ENGINEERING CHANGE NOTICE

1. ECN 187403

GROUT VAULT HEAT TRANSFER RESULTS FOR M-106 GROUT FORMULATION

WHC-SD-WM-ER-064

Figure 1. Asphalt Barrier Grout Vault 2-Dimensional Model.

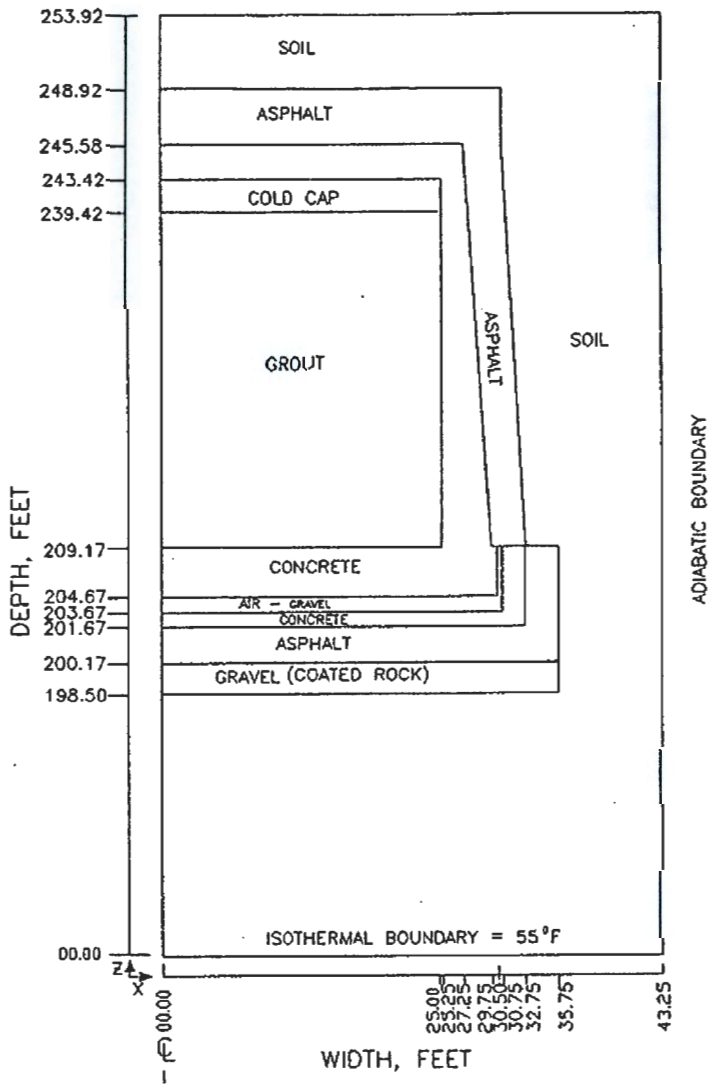
A three dimensional model with the physical dimensions shown in Figure 1 and Figure 2 was used for this update. Figure 1 shows a two dimensional slice in the xy cartesian coordinate plane. Figure 2 shows the actual three-dimensional solid modeled. The overall vault dimensions including the coated gravel on the bottom and asphalt overburden is 50.4 feet high by 75 feet wide by 129 feet long. In addition, the vaults are assumed to be in an infinite array of grout vaults whose side-to-side center-to-center spacing is 86.5 feet and whose end-to-end center-to-center spacing is 161 feet.

Figure 3. Maximum TAPA Model Temperatures.

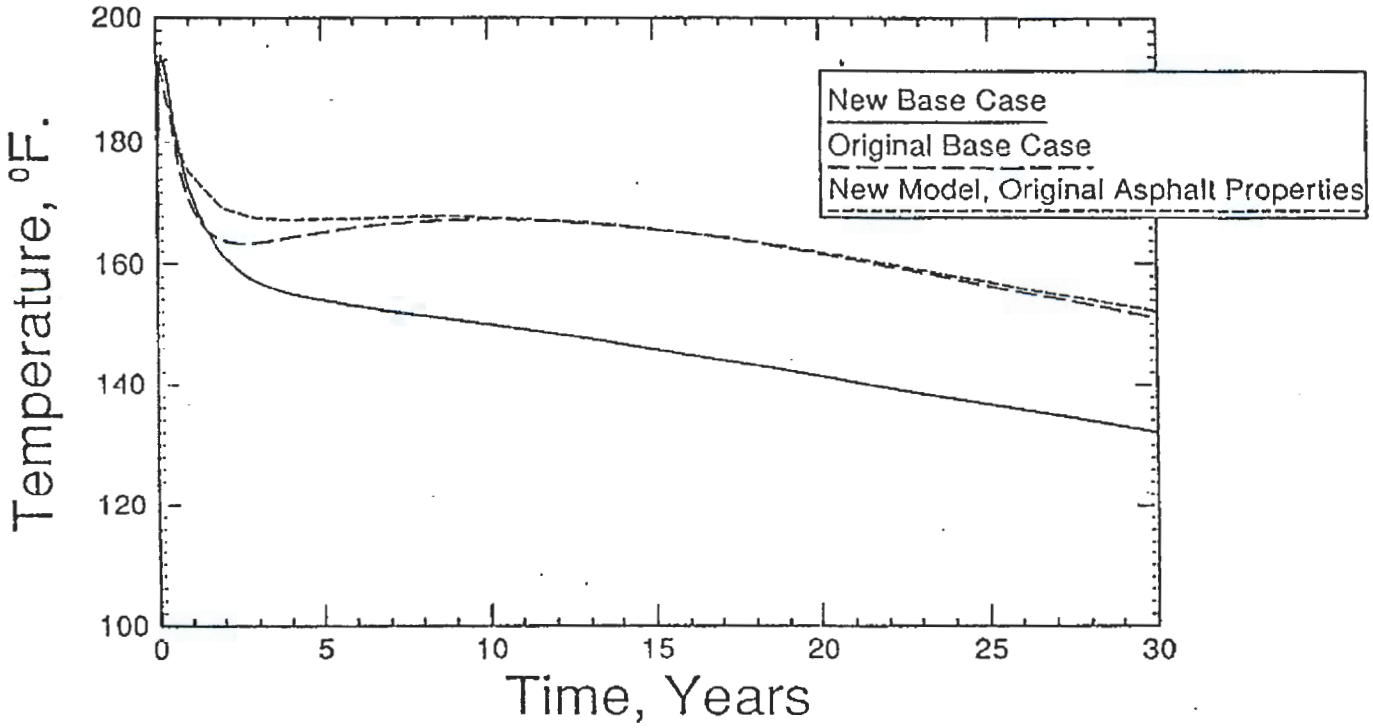
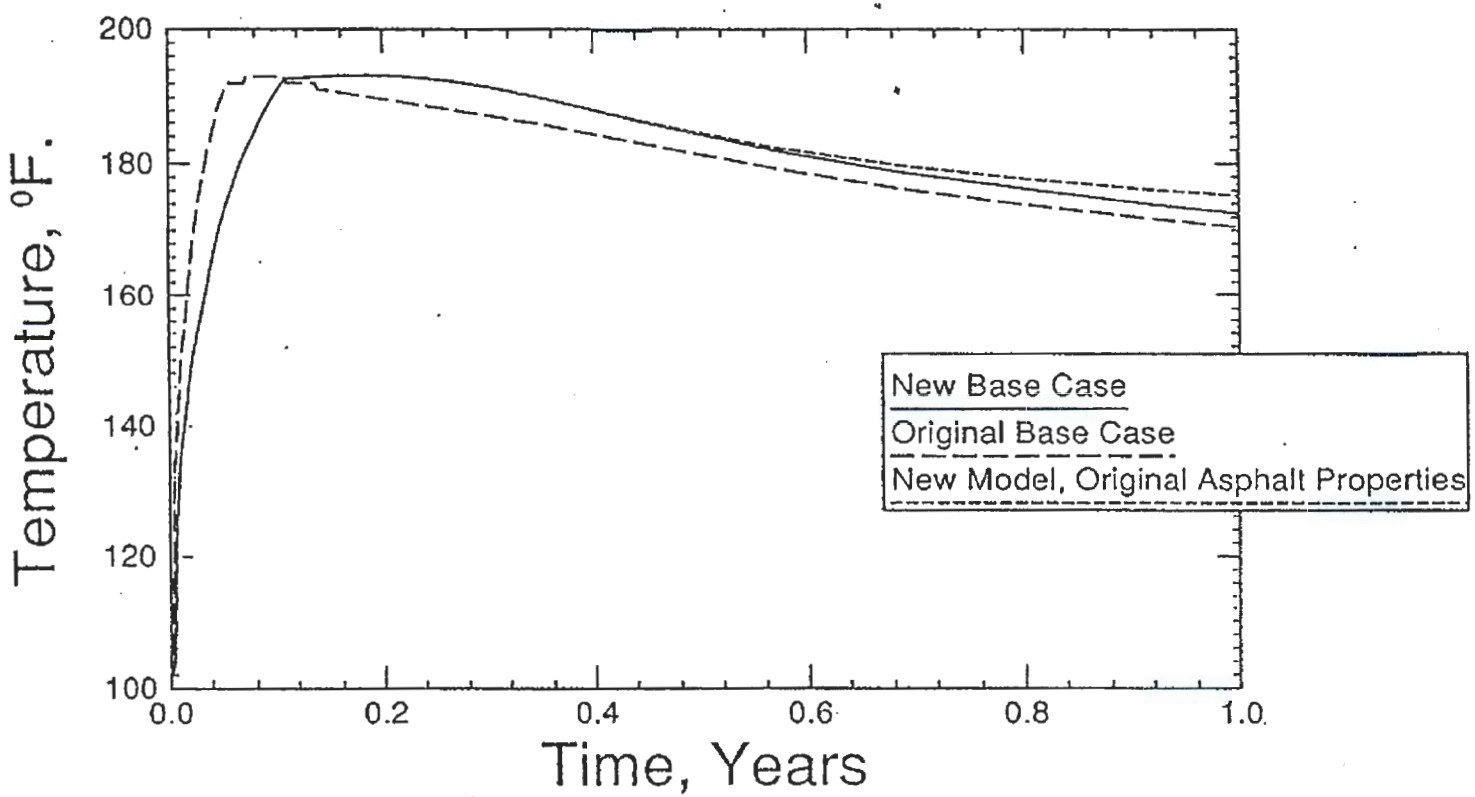
Maximum model temperatures are summarized in Figures 3 and 4. Figure 3 shows temperatures to 30 years; Figure 4 expands the time scale to show the details of the first year. The original base case curve on each of the figures shows the maximum temperatures for the model in Reference 1. This is used to give a base case comparison to the present results. The new base case curve shows the maximum temperatures for the current model. As seen, this curve is significantly different from the original results. To check to see if this difference was due to the different thermal properties or the new model dimensions, the original asphalt thermal properties were substituted in the new model. The results of this substitution are shown as the new model, original asphalt properties curve in Figures 3 and 4. Since this curve matches almost identically to the original model temperature curve, the

temperature differences between the original and the present model are entirely due to the different asphalt thermal properties used. By raising the asphalt thermal conductivity, the asphalt no longer acts as a thermal barrier against heat removal, so there is no second temperature peak due to the radiolytic heat generation rate. As seen, the increased asphalt thermal conductivity has little affect on the short term temperature, but the temperatures after about five years are approximately 20°F lower.
